750 #15  
REV. 1/31/75  
**SERVICE BULLETIN**  
AMERICAN HONDA MOTOR CO., INC. MOTORCYCLE SERVICE DEPARTMENT

### MODIFIED THROTTLE VALVE AND CABLE KIT

CB-750 #15

Addendum

#### IDENTIFICATION:

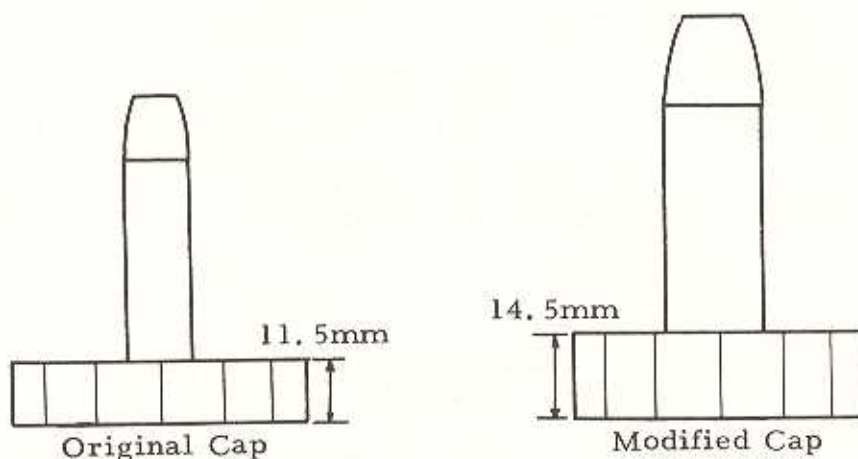
Modified throttle valve and cable kit installation can be identified by visual inspection of the carburetor cap. The modified cap is 3mm taller than the original cap.
